Model: PRIPORT PINKGOLD		Date: 20-May-02	No: M-C238-001
Modified Article: Thin pads		Prepared by: H. Onodera	
From: Priport Service Planning Section			
Classification: ☐ Parts catalog correction ☐ Vendor change ☐ To meet standards ☐ To facilitate assembly ☒ To improve reliability () ☐ Part standardization ☐ Other ()			
Model Name: Ricoh JP3000/JP3800, Gestetner 5430/5428C, RexRotary 1330, nashuatec CP430, Savin 3260DNP, Standard SD370

Model: PRIPORT PINKGOLD		Date: 30-Oct-02	No: M-C238-002
Modified Article: New model PG B4 information (China only)		Prepared by:	
From: Priport Service Planning Section		H. Onodera	
Classification:	☐ Parts catalog correction ☐ Vendor change ☐ To meet standards ☐ To facilitate assembly ☐ To improve reliability () ☐ Part standardization ☒ Other (New machine information)		
Model Name: PINKGOLD: Ricoh JP3000/JP3800, Gestetner 5430/5428C, RexRotary 1330, nashuatec CP430, Savin 3260DNP, Standard SD370, Lanier LDD030 PG B4 (China only): Ricoh JP2800, Gestetner 5425C

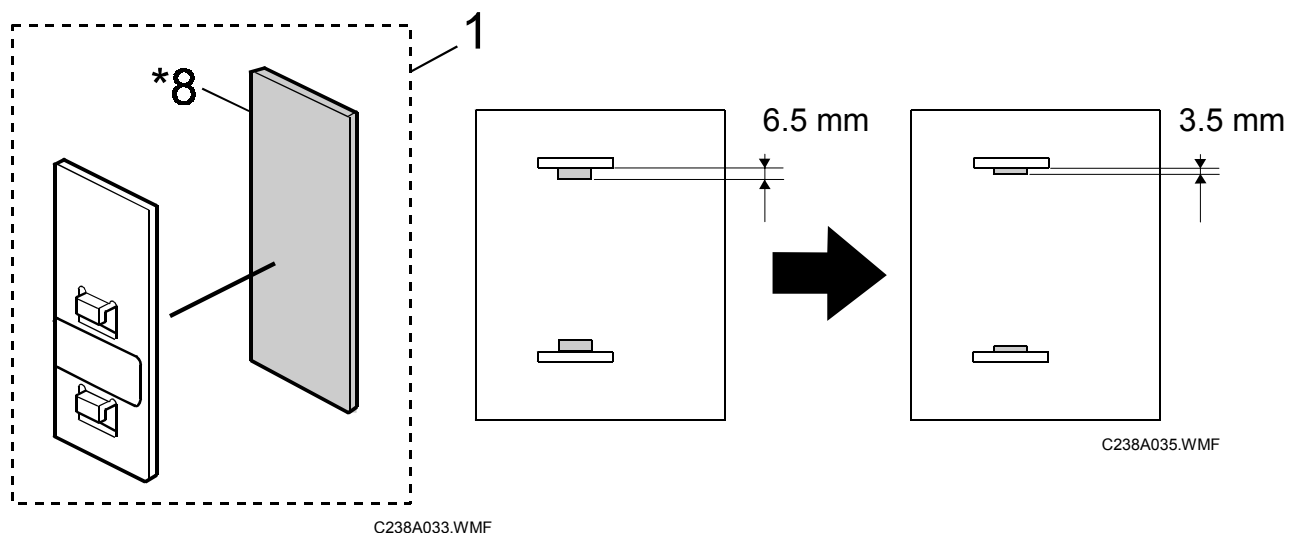
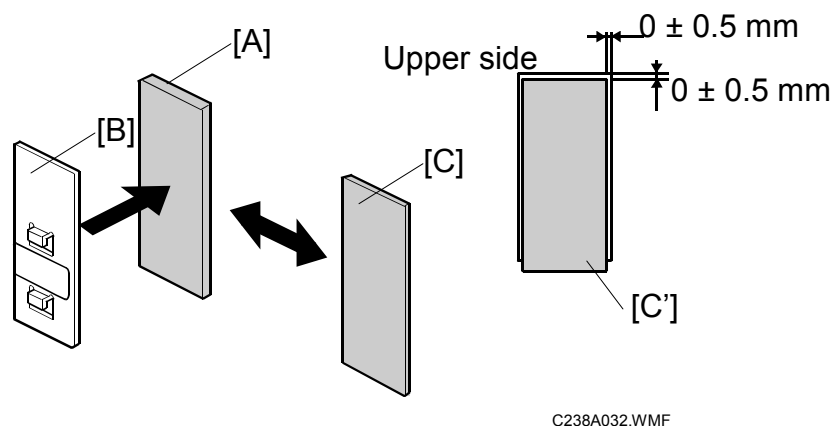
To solve the 7mm image shift, the thickness of the pad below has been decreased from 6.5mm to 3.5mm. As shown below, the new thinner pad is available both as an independent part (C2382772) and as a set with the plate (C2382770). Please see the next page for the replacement procedure, and RTB #RC238002 for more details.

1. Remove the present pad [A] from the plate [B].
2. Attach the thin pad [C] to the plate [B] (same plate can be used).

NOTE: Be sure to align the upper edges of the pad and plate. The pad's lower edge [C'] will then stick out about 2mm from the plate, but this is normal.

Old part number	New part number	Description	Q'ty	Int	Page	Index
C2382771	C2382770	Paper plate thin pad	2	X/O	65	1
-	C2382772	Thin pad	2	-	65	*8

C238A118.WMF

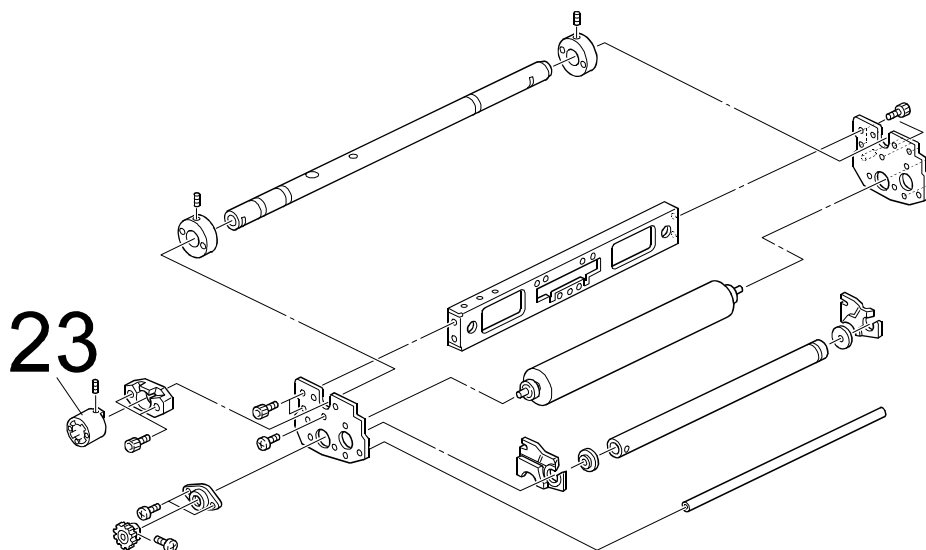
Please correct your parts catalogs as follows.

Incorrect part number	Correct part number	Description	Q'ty	Int	Page	Index
C2382397	C2312397	Front drum shaft collar	1	-	35	23

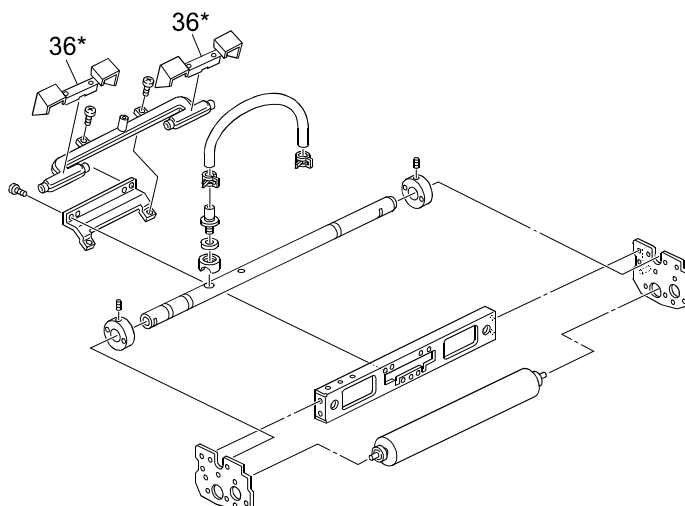
Two ink Pipe Covers (index 36*) have been added to ensure that ink from the ink distributor does not stick to the ink sensor.

Old part number	New part number	Description	Q'ty	Int	Page	Index
-	C2472468	Pipe cover	2	-	35	*36

C238A113.WMF

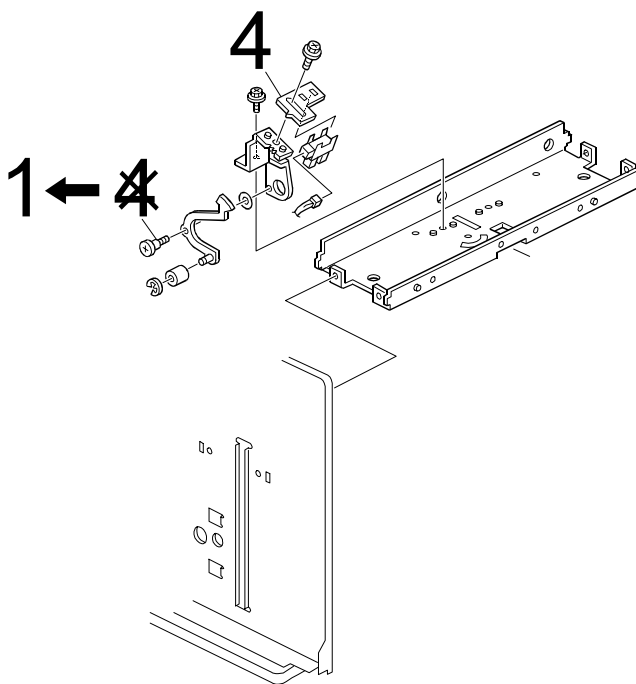
Please correct your parts catalogs as follows.

NOTE: As shown below, the index number (4) for the Sensor Bracket has not been changed.

Incorrect index number	Correct index number	Page	New part number	Description
4	1	21	AA143402	Screw – scale

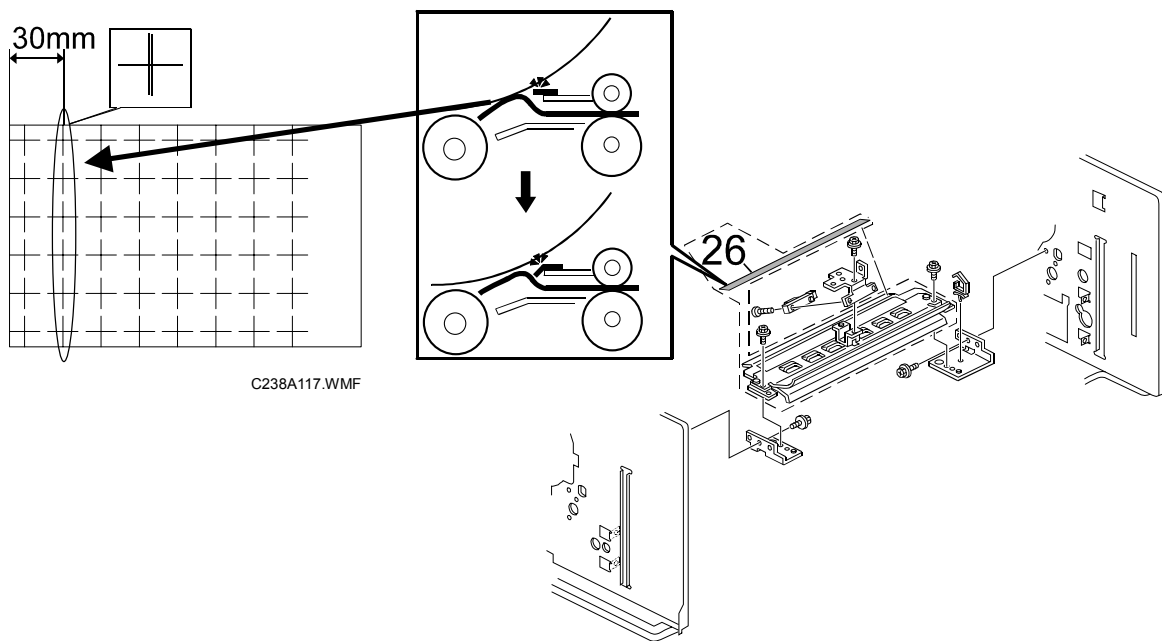
To ensure the paper does not prematurely contact the drum and cause doubled images, the Guide Plate Sheet has been angled downward as shown below.

Old part number	New part number	Description	Q'ty	Int	Page	Index
C2382914	C2382915	Guide plate sheet	1	X/O	19	26

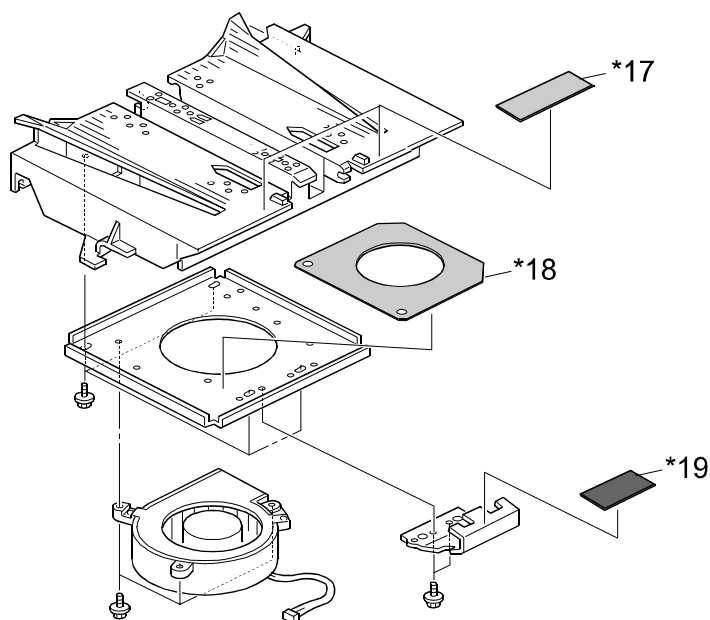
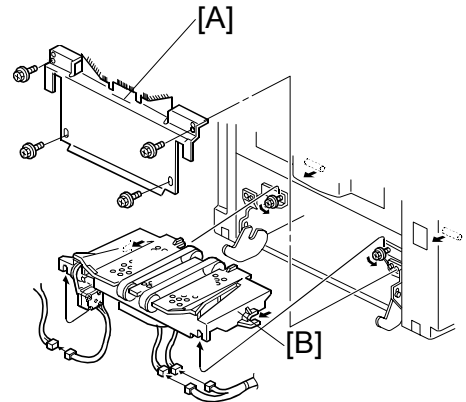
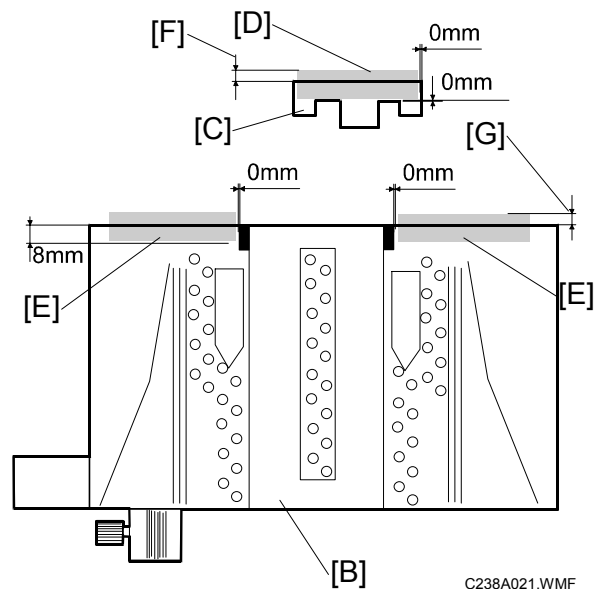
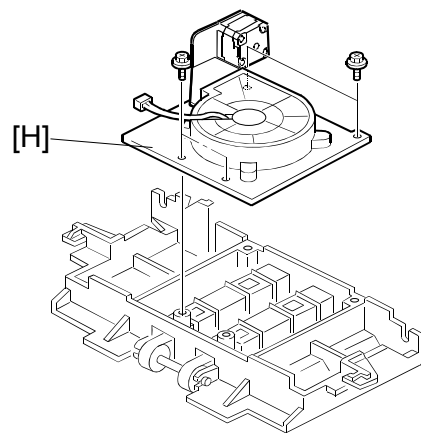
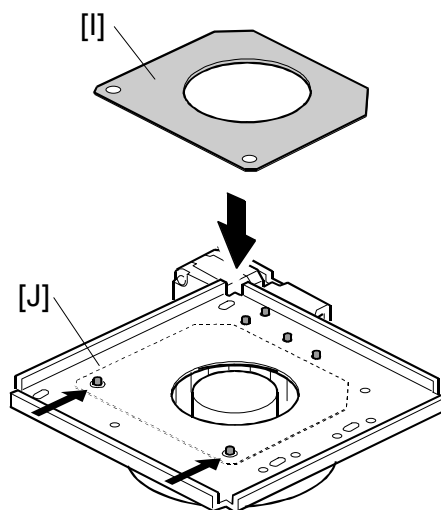
The following parts have been added to China models to ensure that thin paper is properly fed through the delivery unit without jamming. See the following pages for more details on this modification as well as the installation procedure.

The air reduction sheet decreases the airflow around the paper.

5. Attach the paper guide sheet [D] (#C2383892) to the paper guide [C] so that it projects out from the guide 0.8 ± 0.4 mm [F].
6. Attach the 2 paper guide sheets [E] (#C2383893) to the paper delivery unit [B] so that they project out from the unit 2.0 ± 0.5 mm [G].

8. Attach the air reduction sheet [I] (#C2383858) to the fan motor plate [J] as shown.

NO.	Old part number	New part number	Description	Q'ty	Int	Page	Index
1	-	C2383893	Paper guide sheet - long	2	As a set	37	*17
2	-	C2383892	Paper guide sheet - short	1		37	*19
3	-	C2383858	Air reduction sheet	1	-	37	*18

C249A030.WMF

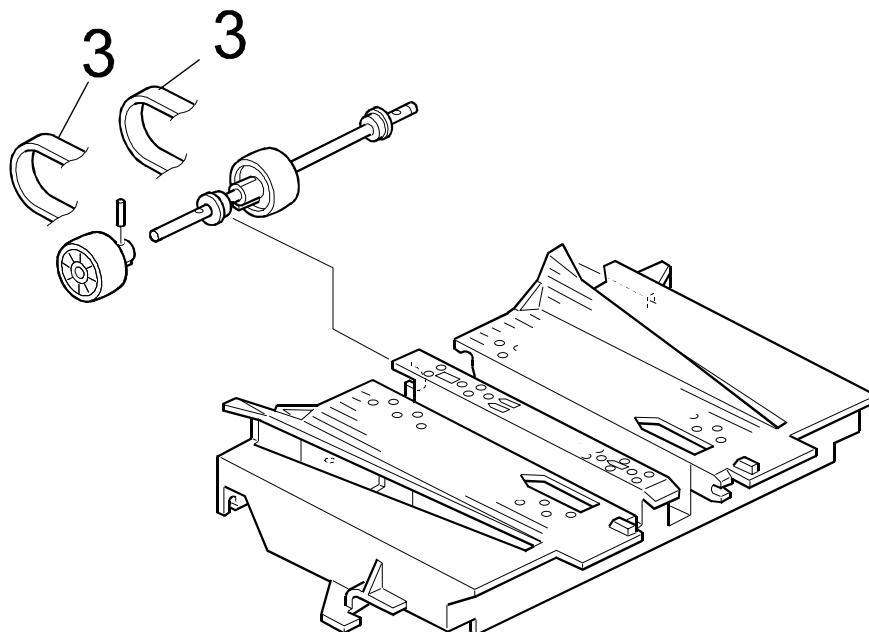
The Transport Belt has been modified so that it has a greater resistance to stretching.

Old part number	New part number	Description	Q'ty	Int	Page	Index
C2383874	C2493874	Transport belt	2	X/O	37	3

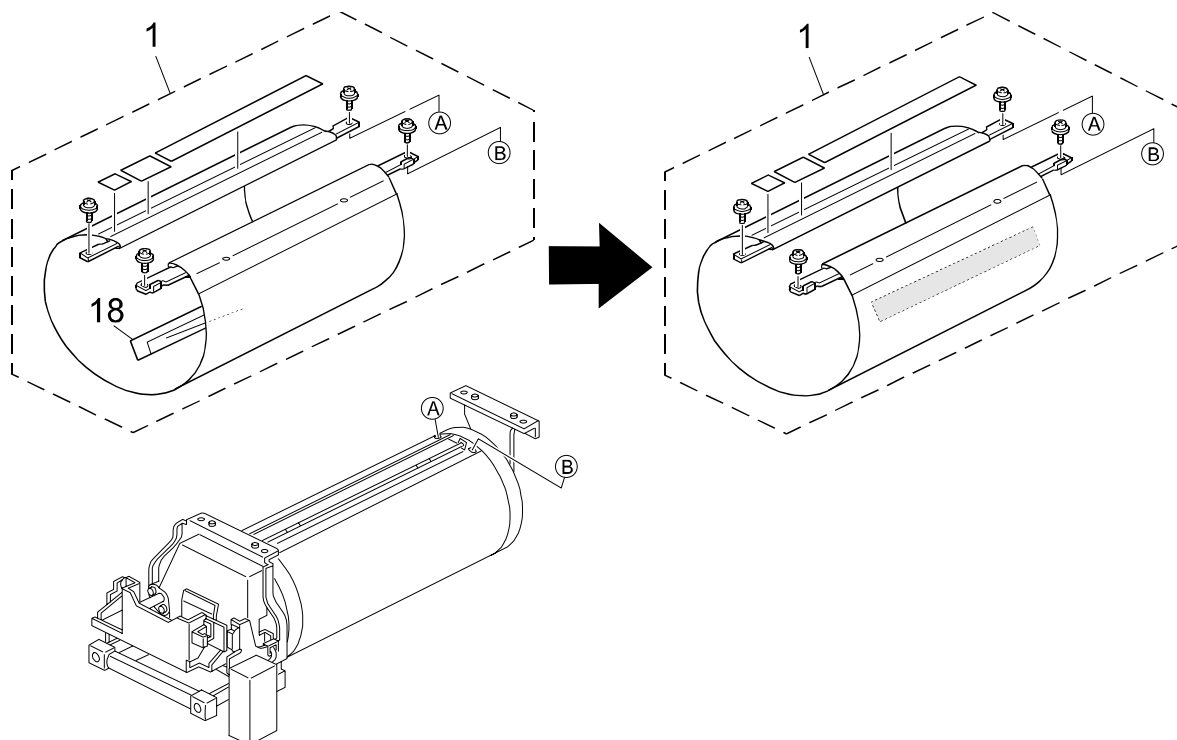
The Cloth Screens have been changed to the ones used on the PGB4, which were modified by combining the screen and sheet into one part to ensure that the sheet does not separate from the screen.

Old part number	New part number	Description	Q'ty	Int	Page	Index
C2382304	C2382381	Cloth screen – A3	1	O/O	31	1
C6092382	C6092381	Cloth screen – A4	1	O/O	31	1
C2382384	-	-	0	-	31	18

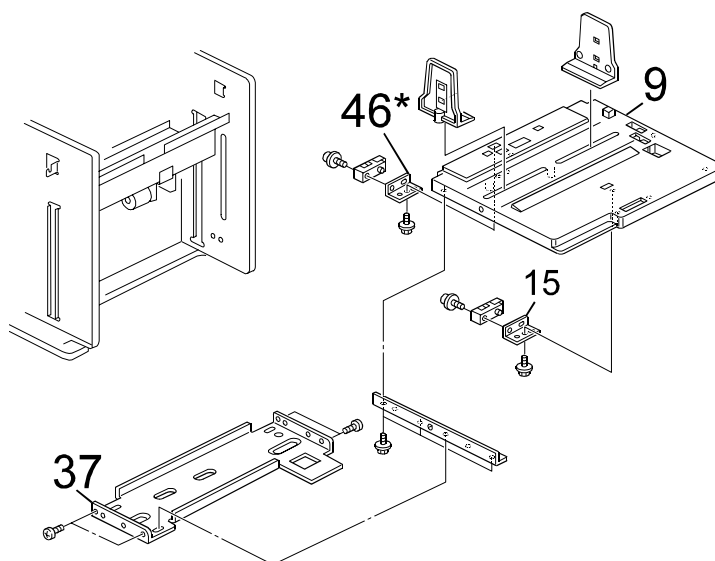
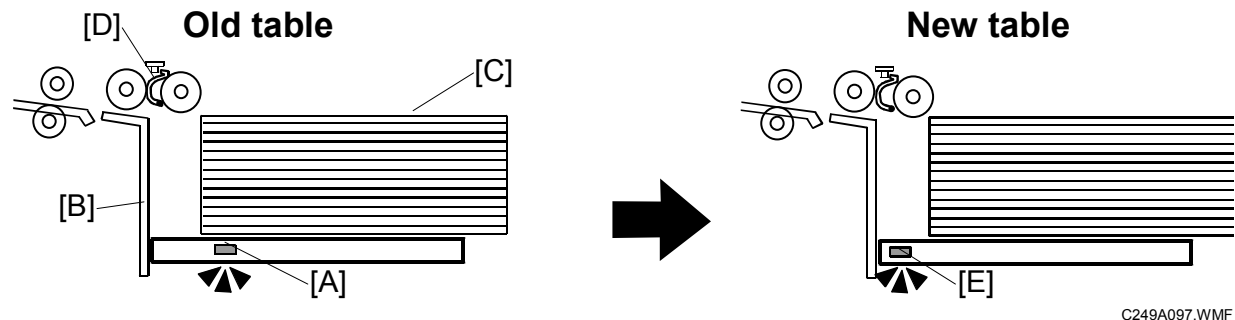
- The end sensor detects the stack, but the pick-up roller cannot catch on the stack and feed the top sheet, causing a feed error.
- The height sensor cannot detect the paper stack, causing the bottom plate to lift the stack beyond the correct point.

Old part number	New part number	Description	Q'ty	Int	Page	Index
C2382950	C2382949	Paper feed tray	1	X/O as a set	17	9
C2382986	-	-	2 -> 1		17	15
-	C2382985	Sensor bracket – paper end	1		17	*46
C2382954	C2382955	Tray base	1		17	37

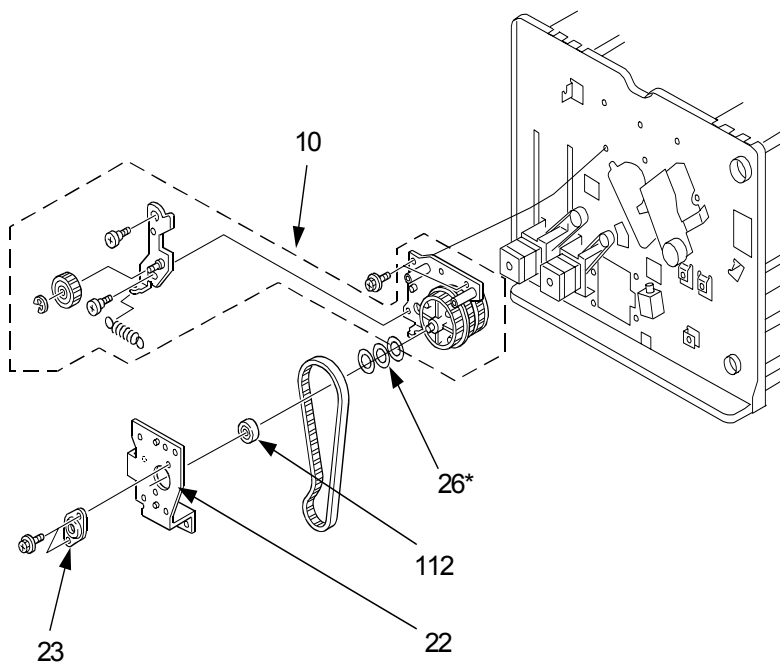
The following three spacers have been added between the Drum Gear Assembly (#10) and Ball Bearing (#112) to ensure that the bearing stays properly fixed in place.

Please use the **C2389000 spacer** newly registered with service parts. See **RTB #RC238009** for the installation procedure and other notes.

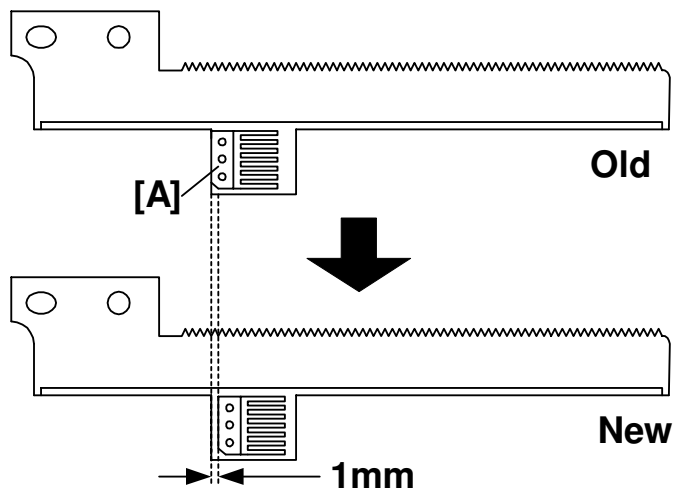
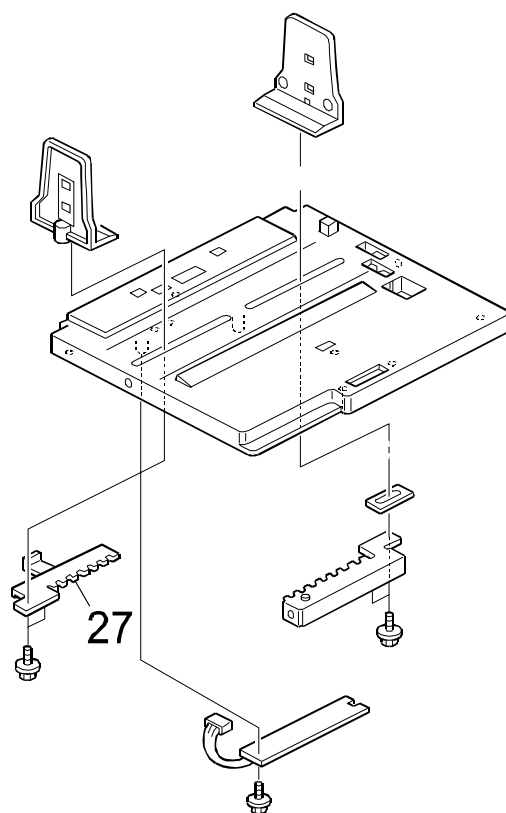
The position of the actuator [A] that is attached to the front side fence rack has been changed to ensure correct contact with the paper size sensor board, and to further ensure correct paper size detection.

Old #	New #	Description	Qty	Int	Page	Index
C2382976	C2492976	Front Side Fence Rack	1	X/O	17	27

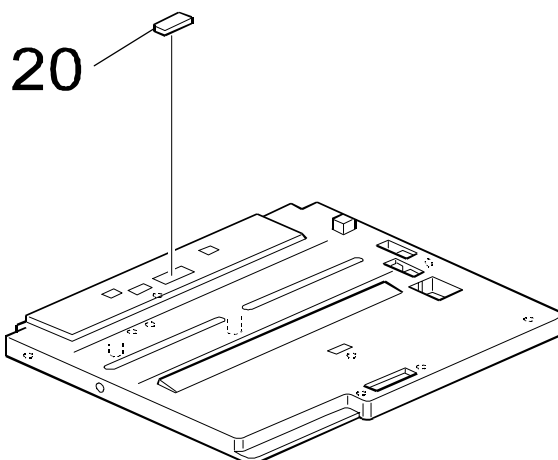
The pressure of the pad on the paper feed tray has been reduced in order to:

- Feed the paper more smoothly
- Further make sure that paper misfeeds (A jam) do not occur in the paper feed section.

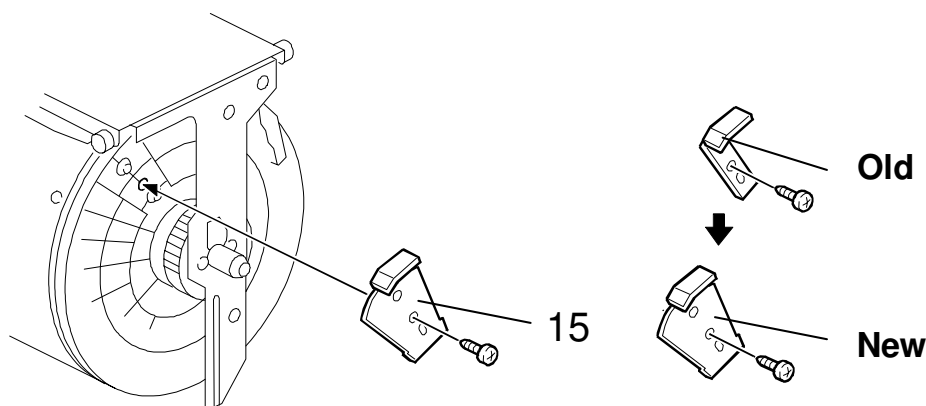
The shape of the drum position plate has been changed to further ensure it stays properly fixed to the rear flange.

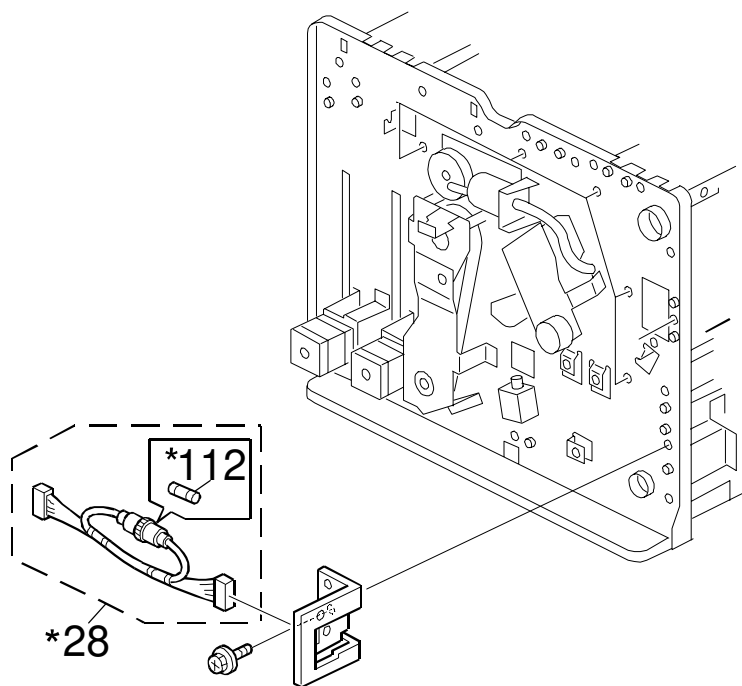
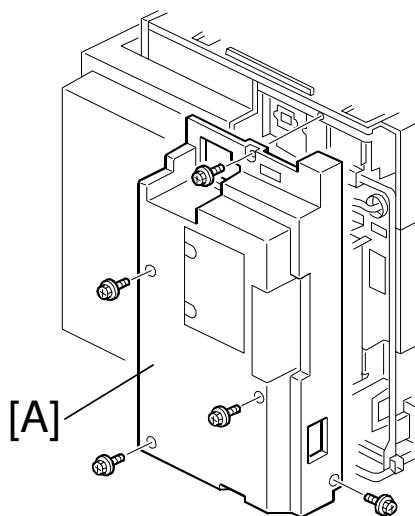
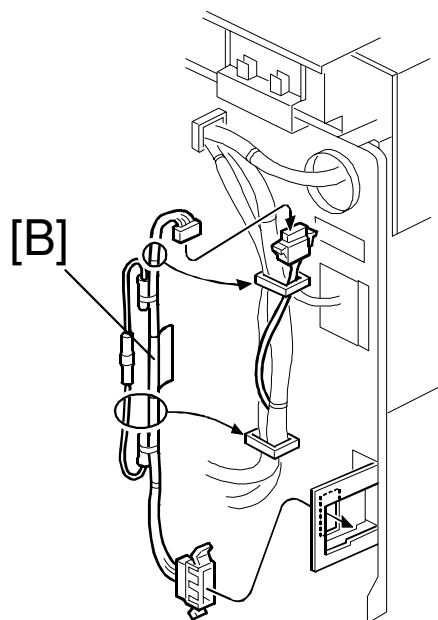
The following have been newly added to further protect the MPU board from unexpected electric surge.

NOTE: Be sure to attach the relay harness when installing the Tape Marker option (Installation Procedure on page 3).

1. Turn off the main switch and disconnect the power plug.
2. Remove the rear cover [A] (⌀ x 5).

3. Install the relay harness [B] (2 clamps).
